Rezoning Transportation Analysis

Petition Number: 2019-115

Date	Description
09-29-2019	First Review
11-15-19	Second Review

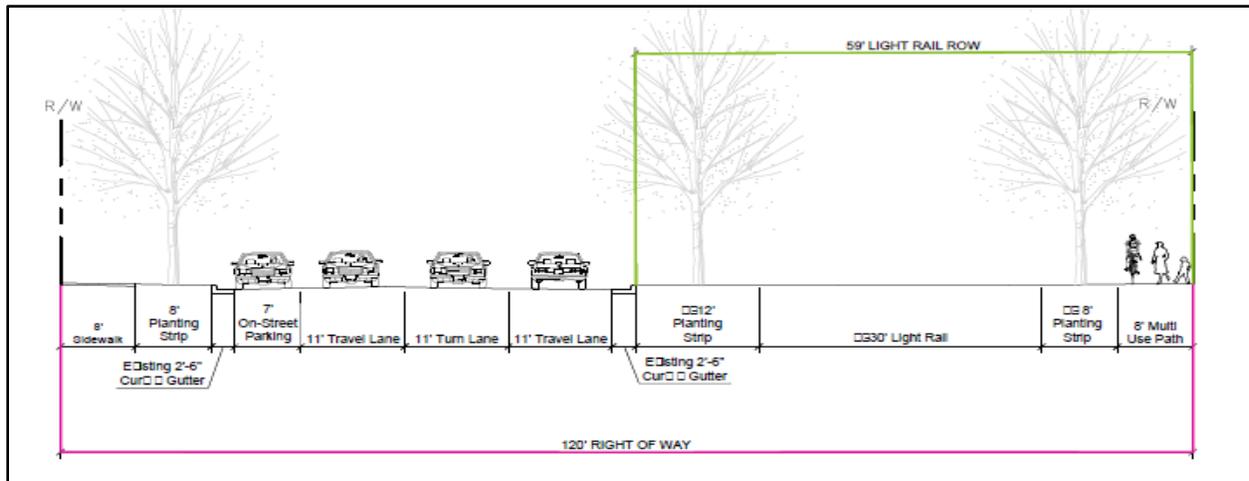
5. **Revised comment based on revised site plan (10/16/19):** The petitioner should revise the site plan on Sheet RZ-7.0B and conditional notes to show the proposed cross-section for Ballantyne Corporate Place incorporating the future light rail alignment. The petitioner should include language committing to dedicating and/or reserving 120' of right-of-way for the future light rail (see the below conceptual street/light rail cross section on Ballantyne Corporate Place).

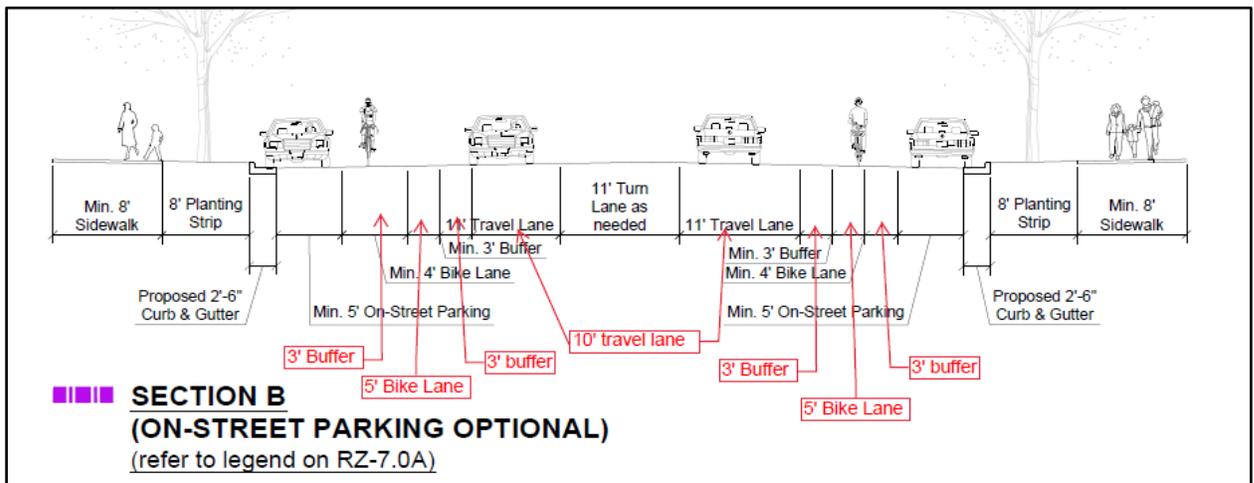
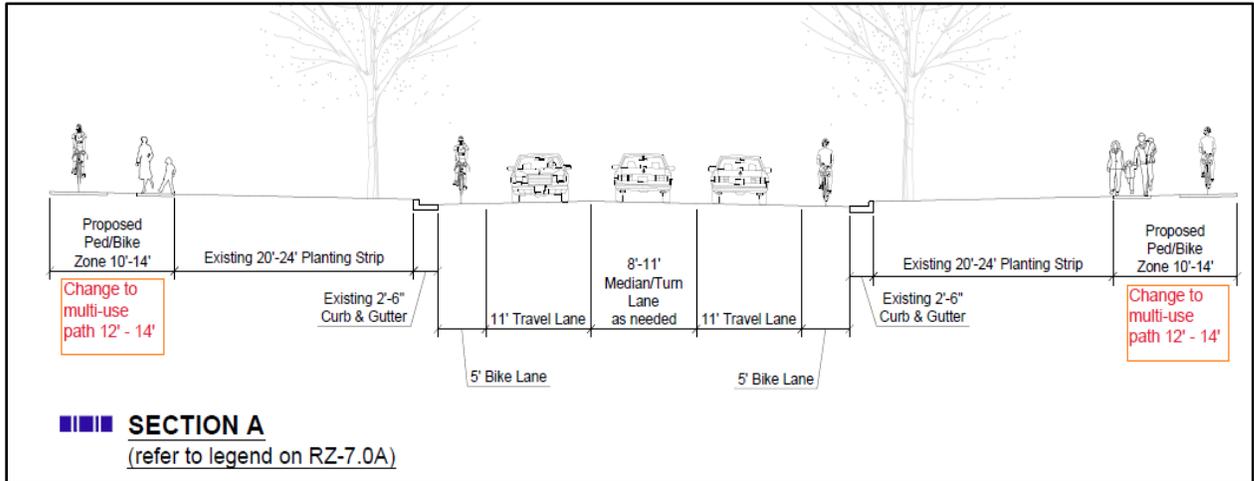
- c. The petitioner should revise the site plan and conditional notes showing the internal road network cross-sections meeting USDG Standards Per Chapter 20 Subdivision ordinance and the City's Charlotte BIKES policy on Sheet RZ-7.0B. The petitioner should include the USDG street typical each cross-section is meeting.

- 13. Sheet RZ-7.0B shows 2 "Section D" cross-sections and conflict with the street network on Sheet RZ-7.0A. The petitioner should revise the site plan showing the correct matching cross-sections between Sheets RZ-7.0A and RZ-7.0B.

- a. **Comment Clarification Based on Revised Site Plan (10/16/19):** Section D cross section in Sheet RZ7.0B should be labeled Section "E" to match the site plan in Sheet RZ 7.0A.

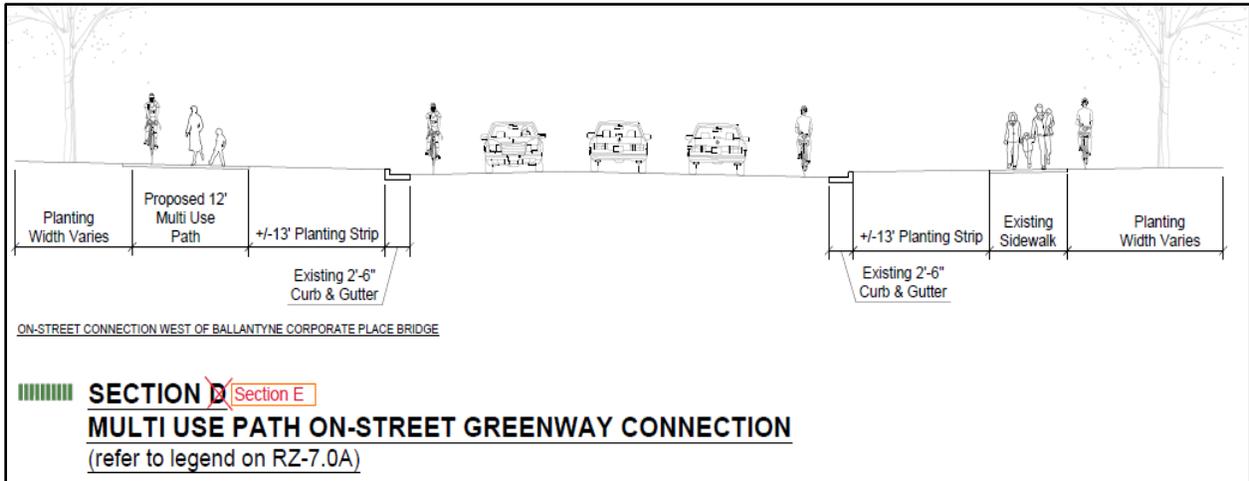
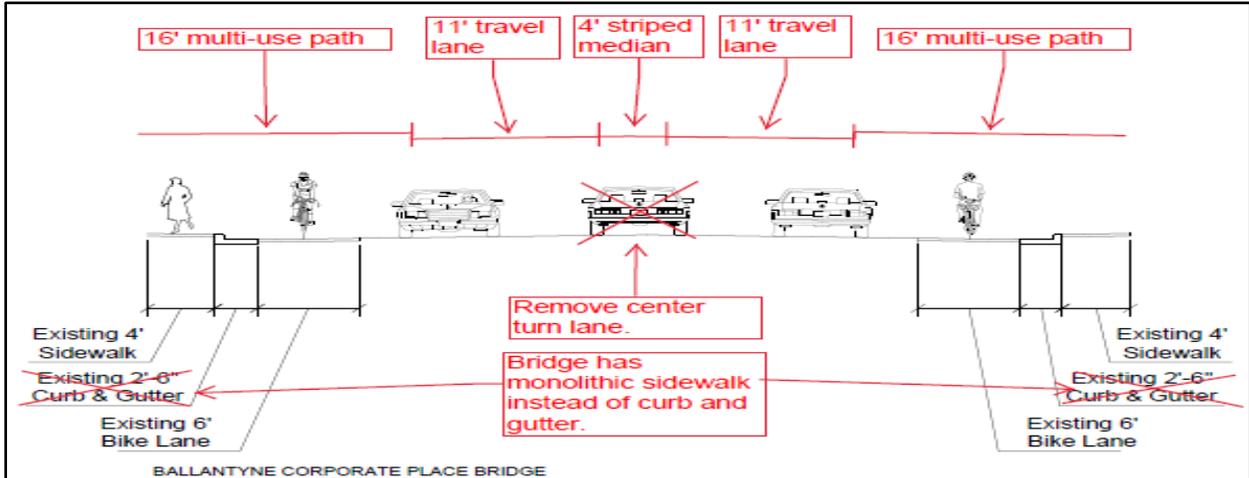
14. The petitioner should revise the site plan and conditional notes to commit to reallocating space on Ballantyne Corporate Place bridge over Johnston Road/521 to be 2 travel lanes, buffered bike lanes, and 8.5' sidewalks.
- a. **Comment Clarification Based on Revised Site Plan (10/16/19):** The Ballantyne Corporate Place bridge cross-section as depicted on RZ-7. OB should be updated to reflect the comments provided below. Furthermore, the total width on the cross-section shown on the rezoning plan does not match the existing width of the bridge. The petitioner should verify the correct width of the bridge is shown accurately on the rezoning plan.
